**LEBANON PLANNING BOARD  
AUGUST 9, 2021 - 6:30 PM  
COUNCIL CHAMBERS, CITY HALL OR  
REMOTE VIA VIRTUAL PLATFORM  
LEBANONNH.GOV/LIVE**

**Agenda Item #3A  
Public Hearing Items**

**St. Johnsbury  
Automobile Group  
(applicant) and  
ORQT, LLC  
(property owner),  
425 Miracle Mile  
(Tax Map 103, Lot 15),  
Zoned GC  
PB2021-19-SPR**

**Mason Storage, LLC, 38 Spencer Street (Tax Map 78, Lot 39), zoned LD:** Request for Site Plan Review to construct a 15,000 sq. ft. addition to an existing warehouse building. PB2021-13-SPR

SITE PLAN  
FOR  
MASON STORAGE, LLC  
IN  
LEBANON, NH

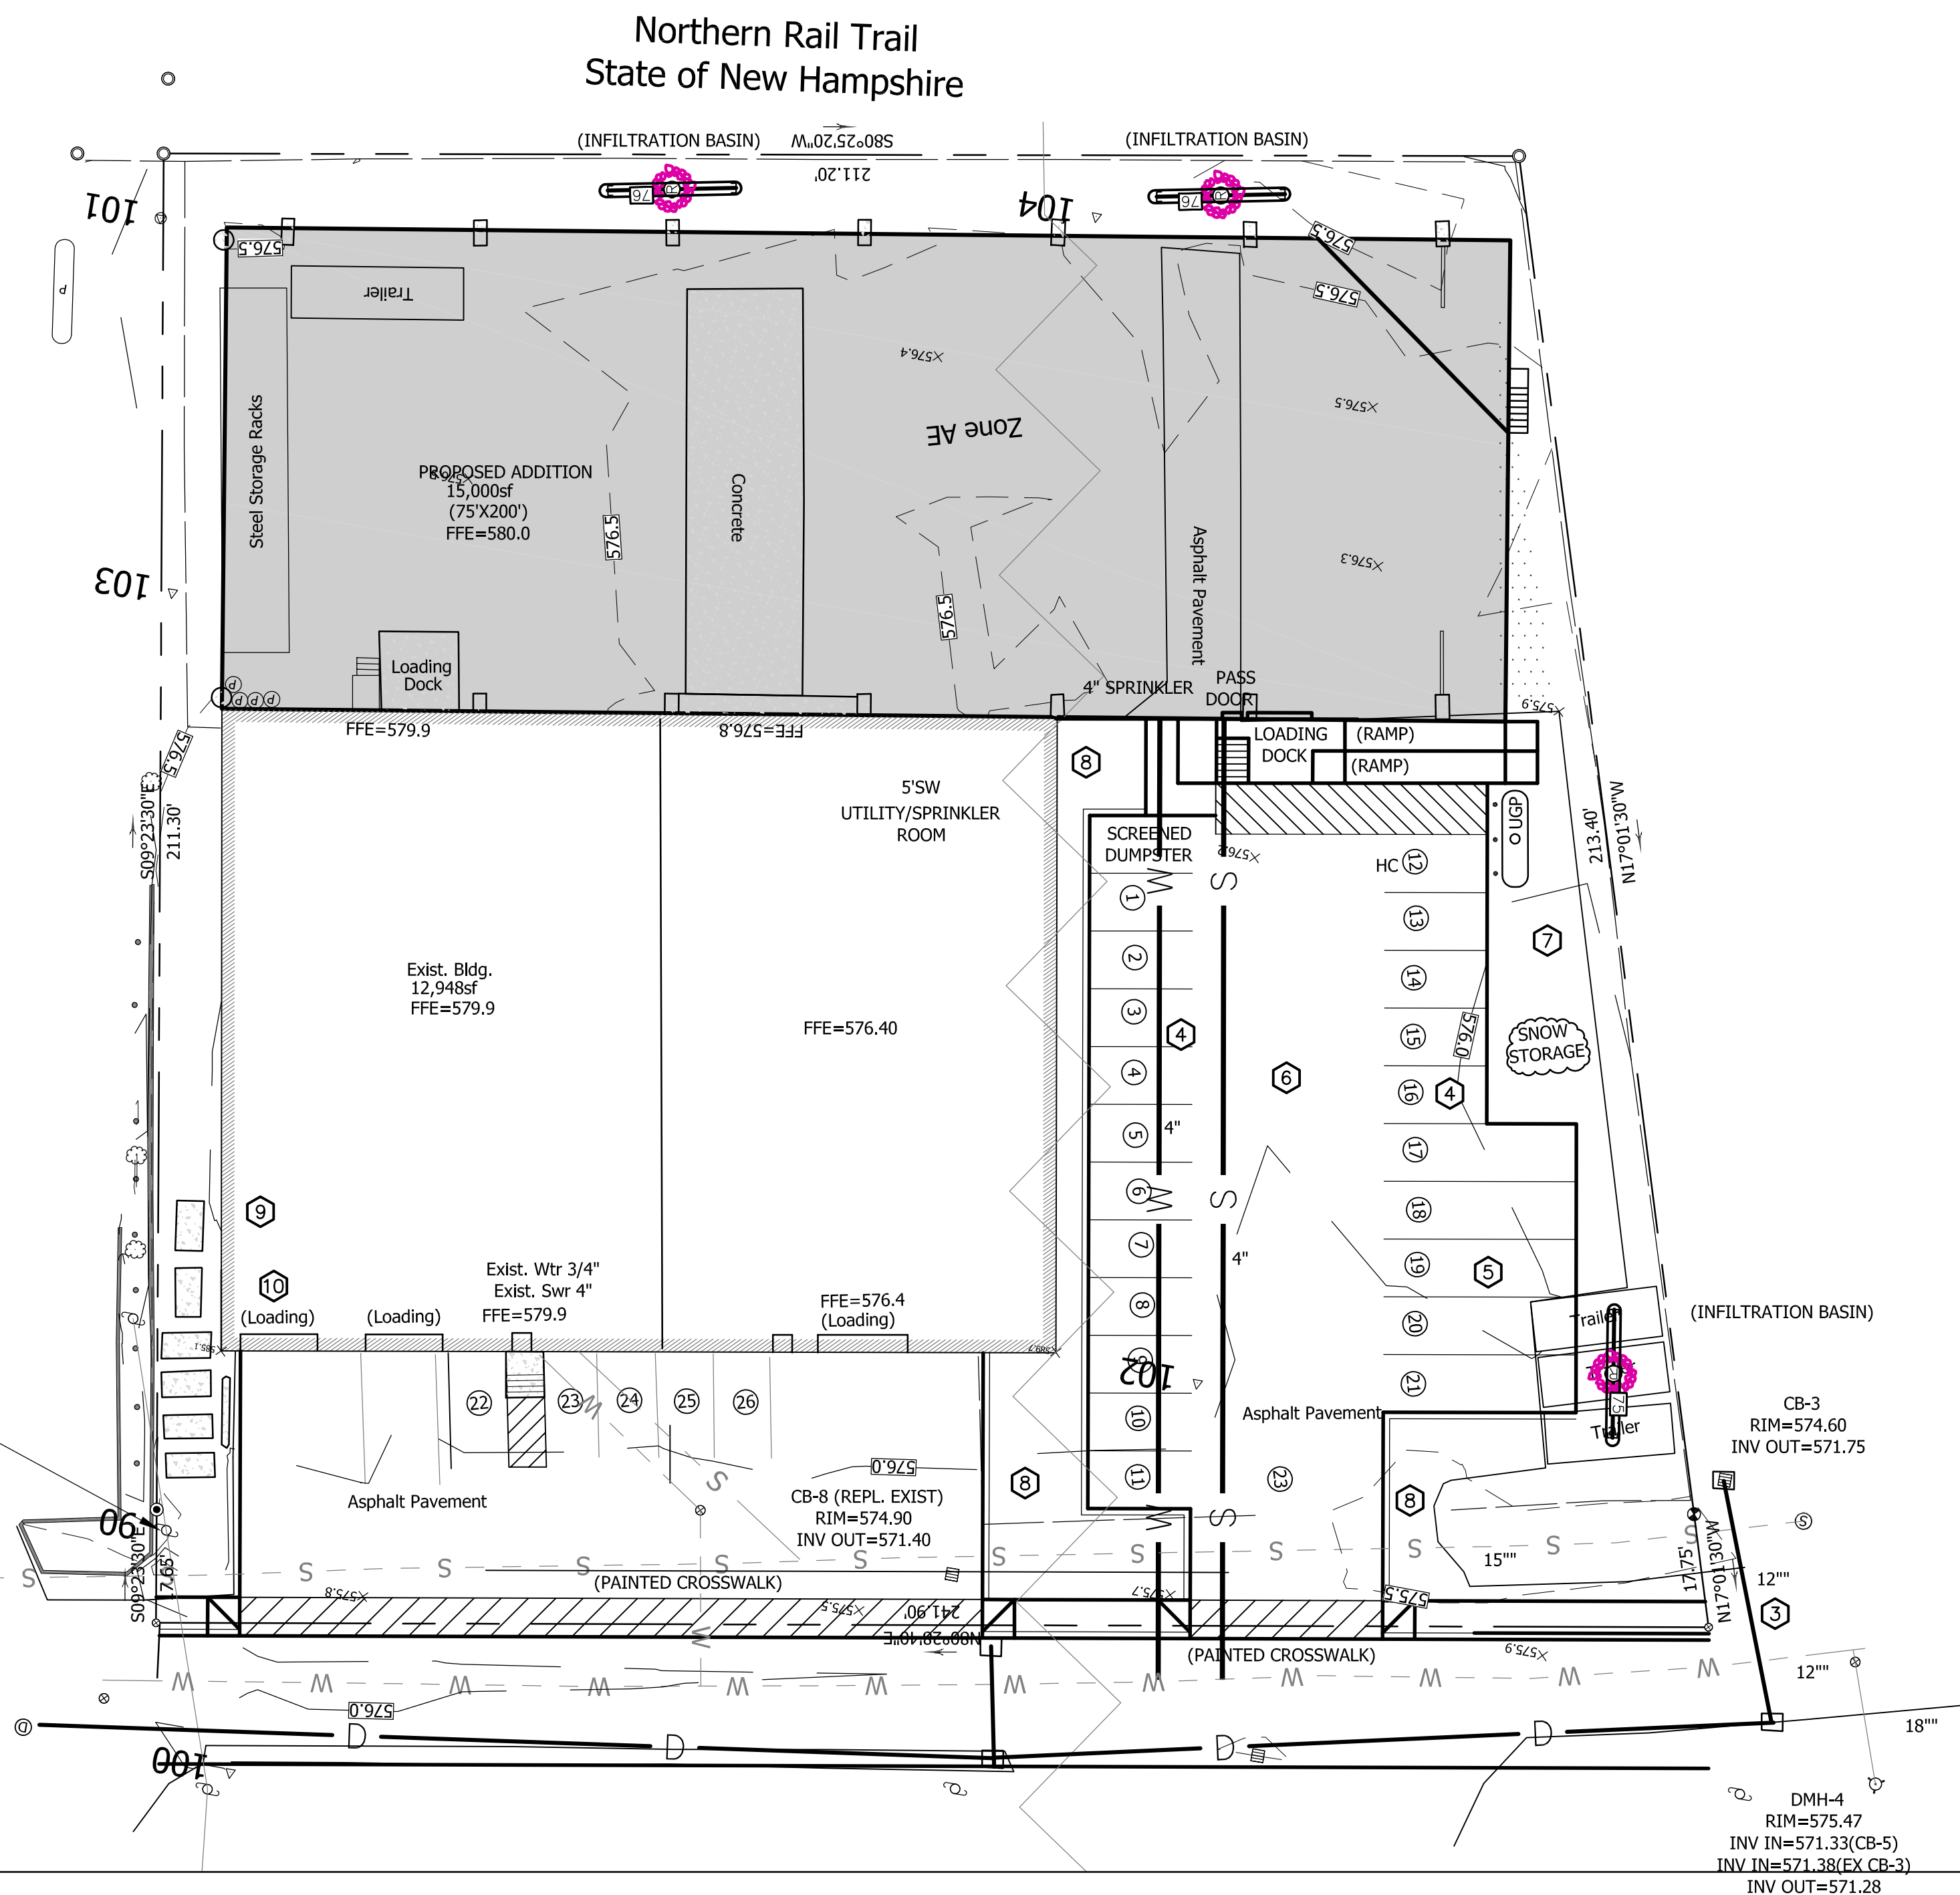
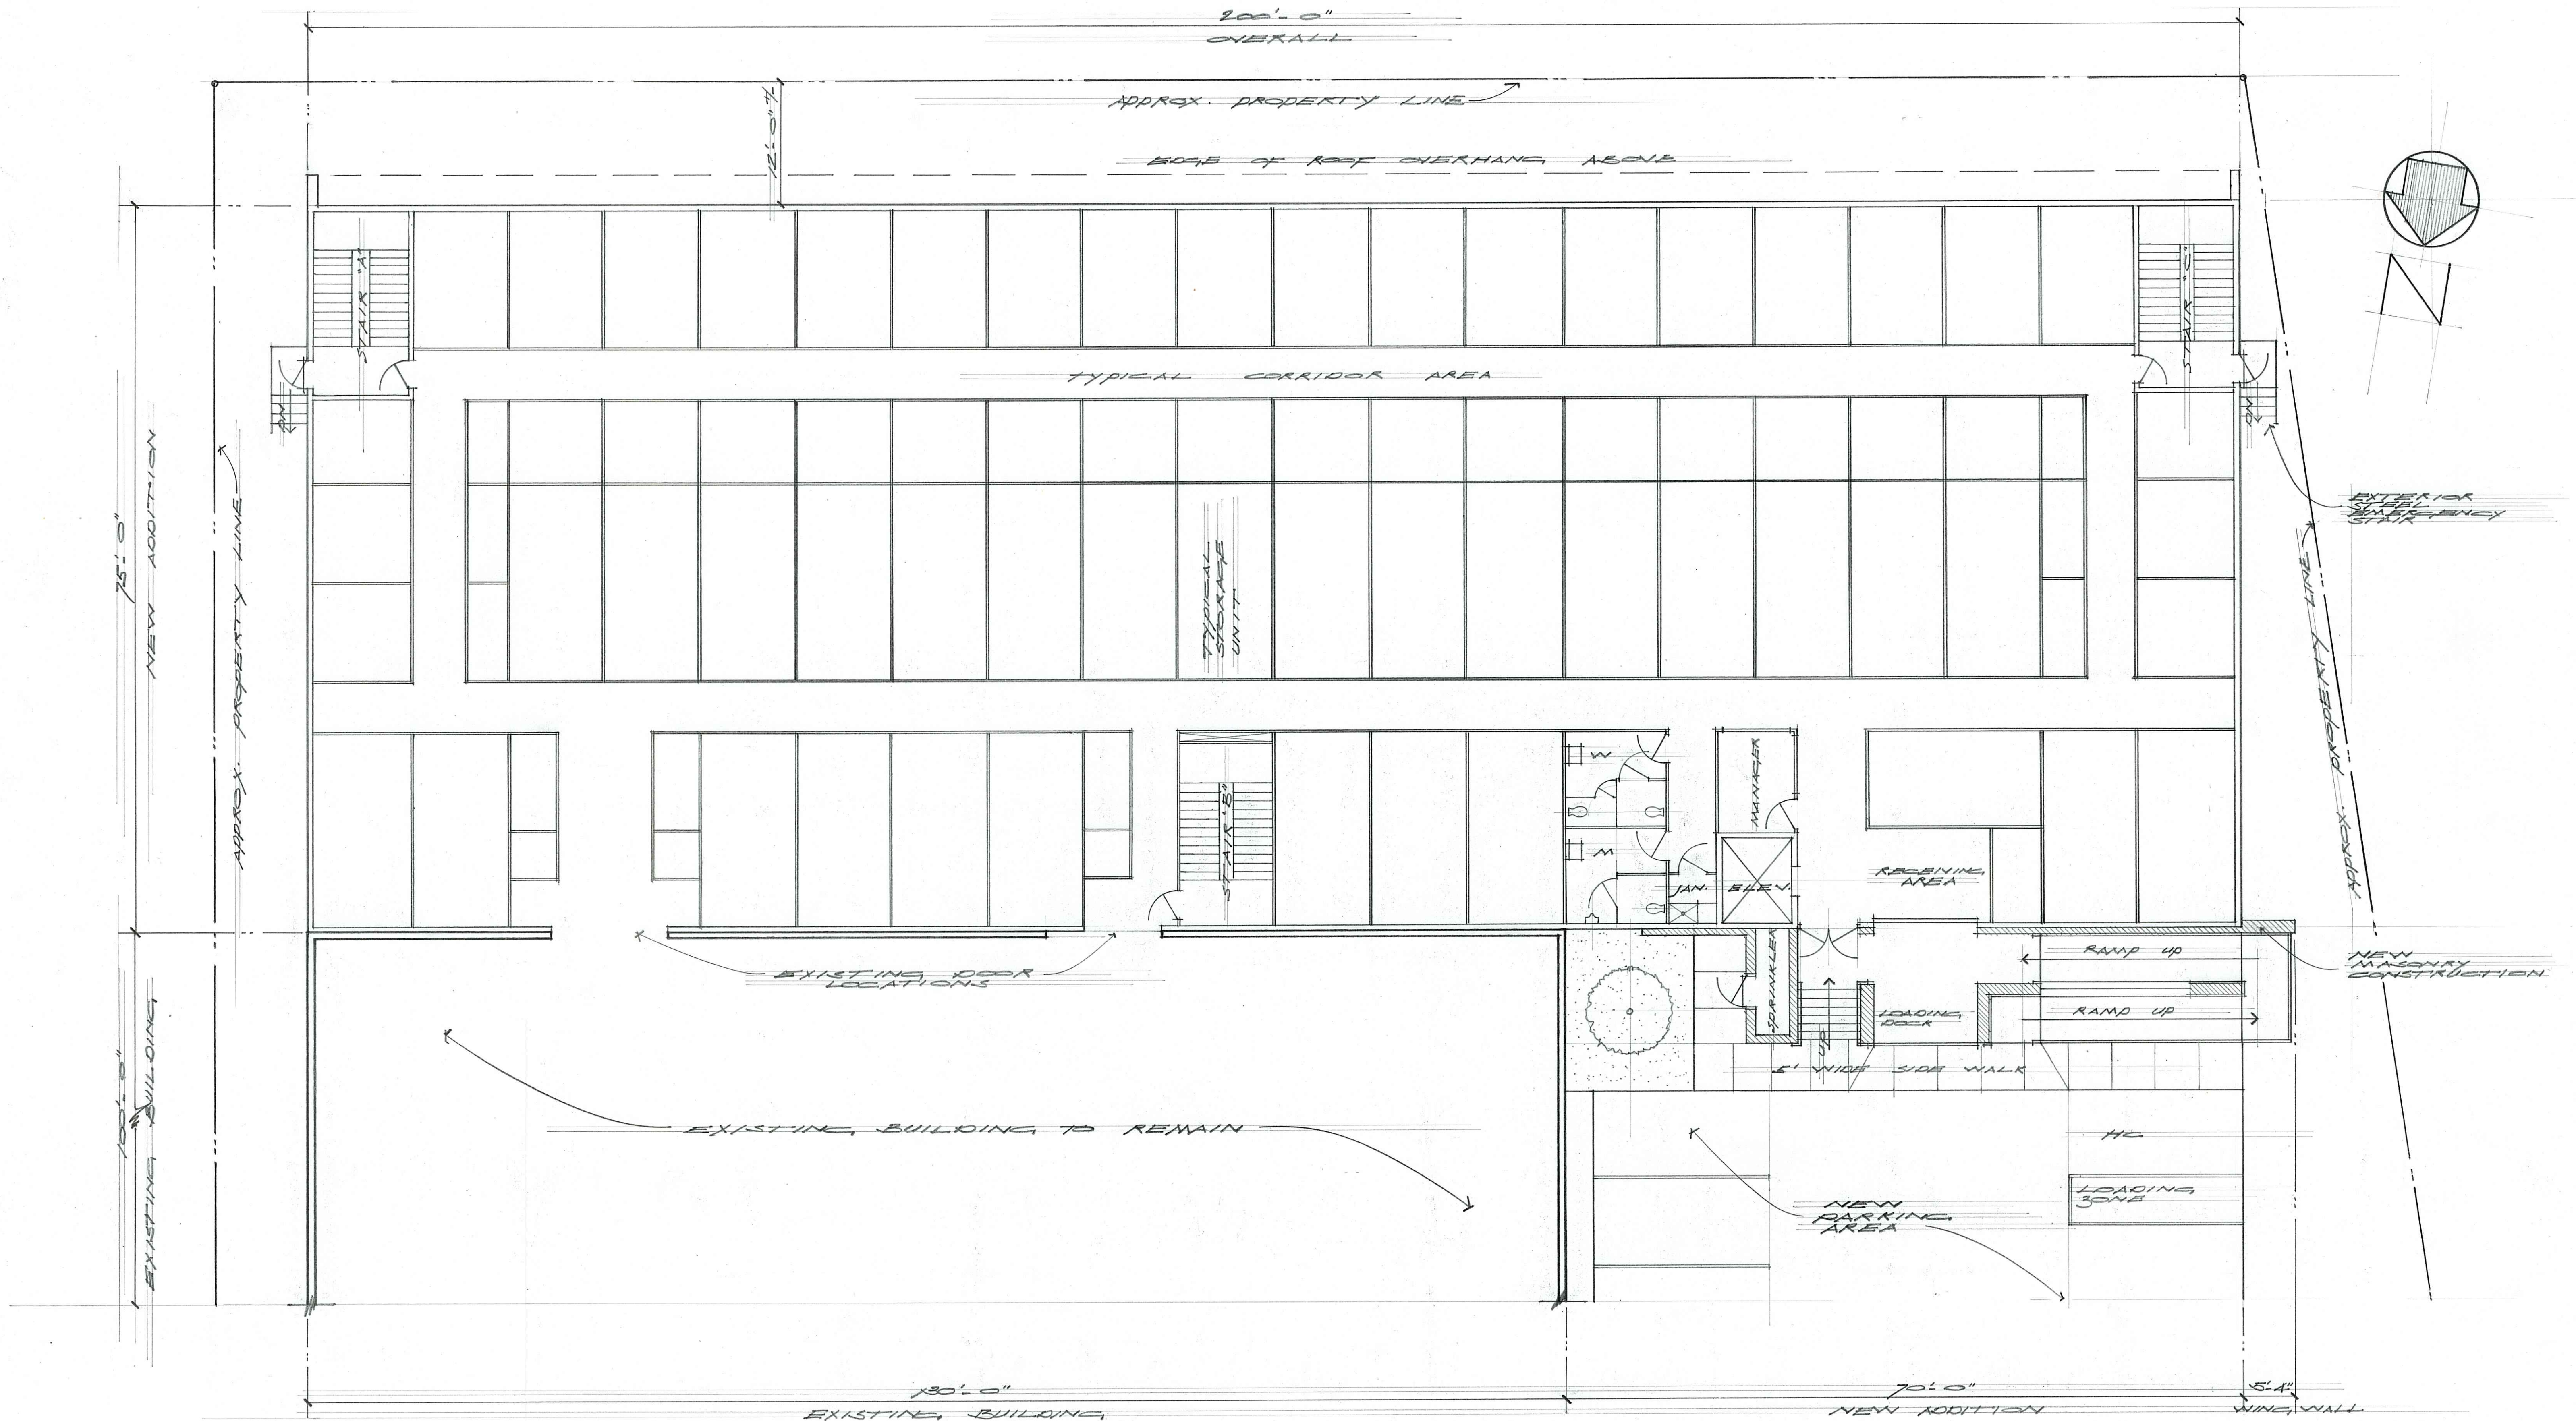
- The following comments of the Senior Planner, provided to the applicant via e-mail on May 10, 2021, remain unaddressed, or partially unaddressed:
  - Streetscape improvements: The site plan [Sheet 5 of 14, i.e. Sheet C-1] is very difficult to read and, therefore, it is not clear what improvements are proposed at the front of the property. However, please note that there should be a proposal for streetscape improvements consistent with Section 6.5.B.2 (complete streets policy), and as required by Section 6.2.B (perimeter landscaping requirements), Section 6.5.B.4 (sidewalk requirement), and Section 6.10.C.2.B (the Lebanon Downtown front yard requirements for commercial uses). This proposal should be discussed with the Department of Public Works prior to submitting revised plans.

- (Regarding the proposed dumpster,) please provide screening as required by Section 6.2.B.8 of the Site Plan Review Regulations.
  - Regarding the site plan (Sheet 5 of 14, i.e. Sheet C-1):

- The site layout utilized for the landscaping plan does not match the site layout shown on the site plan sheet (i.e. Sheet 5/Sheet C-1 of the plan set).

**Parking:** A total of 26 parking spaces are proposed, as shown on Sheet 5 of the Plan Set (i.e. Sheet C-1). However, 28 proposed parking spaces are identified in the "Zoning Comparison – LD District" chart on the cover sheet. The applicant should clarify which number is correct. Note that there is no minimum number of parking spaces required nor any maximum number of parking spaces permitted in the LD District. Rather, per Section 607.4 of the Zoning Ordinance, parking requirements are determined by the Planning Board through Site Plan Review.
